January 24, 1992  
LD-92-007

Docket No. 52-002

Subject: Response to NRC Requests for Additional Information

RESPONSE TO NRC REQUESTS FOR ADDITIONAL INFORMATION  
MATERIALS AND CHEMICAL ENGINEERING BRANCH,  
STRUCTURAL AND GEOSCIENCES BRANCH,  
PLANT SYSTEMS BRANCH

# SYST 80 LAT LOCA (100 FPIB, BILINEAR) . LEGAL FORCE ON C55 (165)

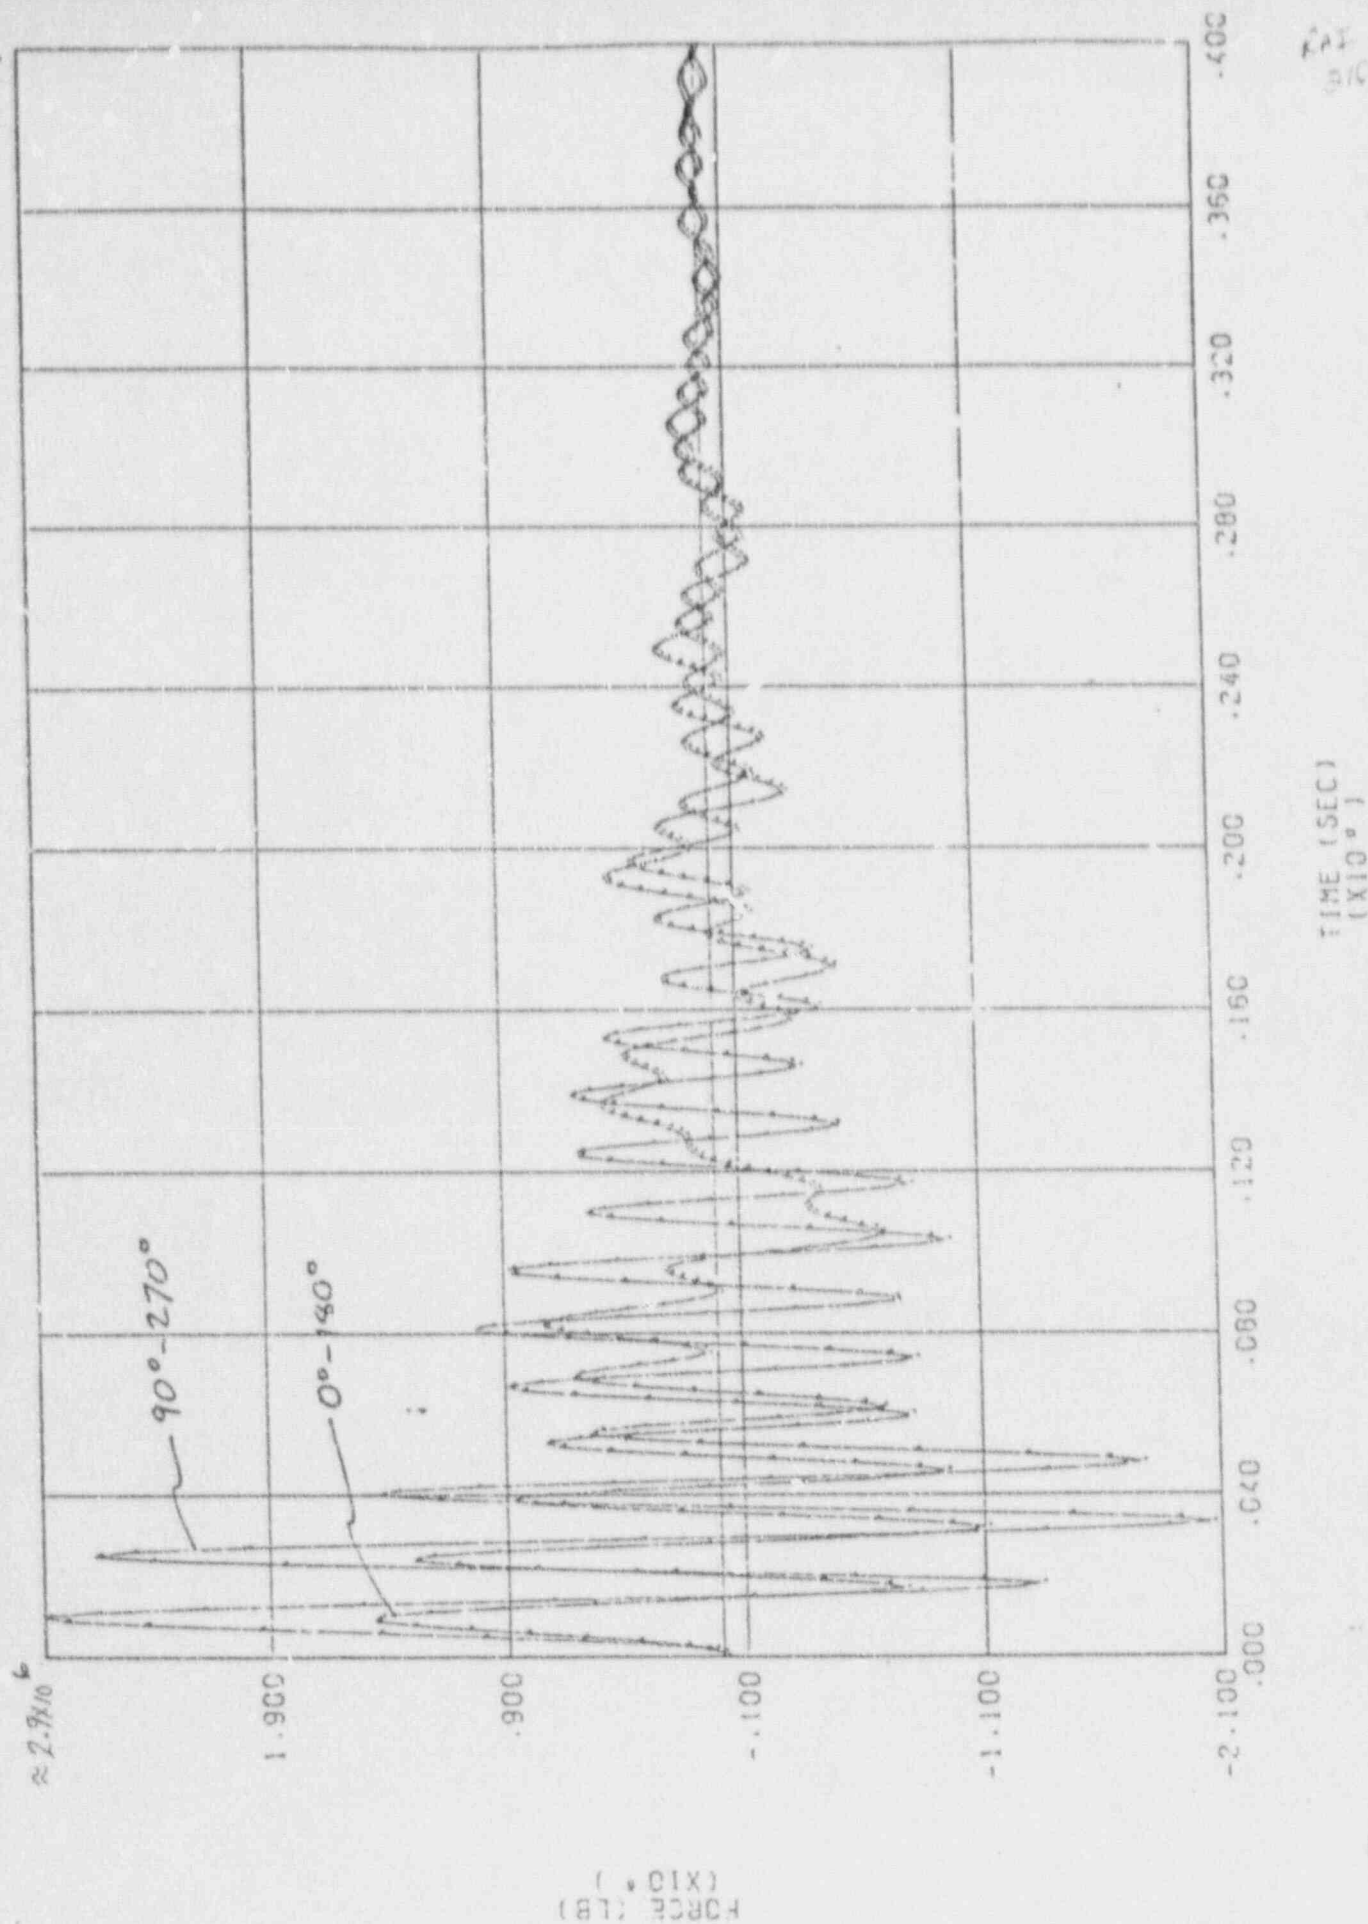
The proposed resolution to GSI-119.1 concerning pipe rupture requirements indicated that LBB will be applied to certain piping systems including the pressurizer surge line. Also, the response to NRC Question 440.46 (see Enclosure I in your letter LD-91-024, dated May 16, 1991), indicated that measures are taken to ensure design adequacy of the surge line, including appropriate routing and arrangement of the surge line to minimize the effects of thermal stratification and to maintain acceptable stress, fatigue, and deflection levels.

Since LBB application requires staff approval of system specific analyses, verify that LBB analysis is complete and can be utilized to justify that protection against dynamic effects of the postulated pipe break is not needed in the surge line (reference RAI's 210.13 and 252.03). In addition, verify that analysis concerning thermal stratification and stripping effects to the surge line is complete. Provide drawings of surge line layout and a summary description of the analysis results to demonstrate compliance with the applicable Code and Standard requirements.

With respect to increasing the SSE loads by a small factor to account for asymmetric blowdown loads associated with a small break LOCA, provide explanations of the magnitude, direction and dynamic nature of the blowdown loads to verify the adequacy of the factor used.

A typical small cold leg break LOCA blowdown response is shown in attached Figure 1. Two curves are presented, one

for the resultant load parallel to the hot legs and the other perpendicular to the hot legs. Also, a study was made to determine the System 80+ internals responses for a 30 inch cold leg break. Table . shows the resulting peak component shear loads and moments and SSE response loads. The results show in all cases that the combined SRSS design load increases are less than 10 percent since the LOCA loads are all less than 0.46 times the SSE loads, thus verifying the adequacy of the factor used.
